Product Change Notice

- CPS22IF-PLWH-12RGB
- CPS22IF-PLWH-24RGB

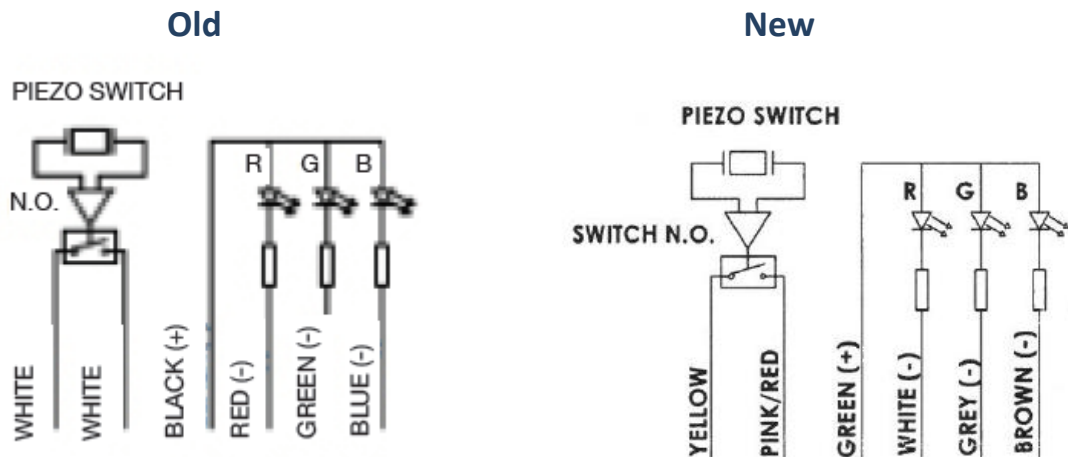
- Switch housing has been extended by 5mm to 25mm due to the addition of a grey plastic ring
- Wire colours have been changed as follows:
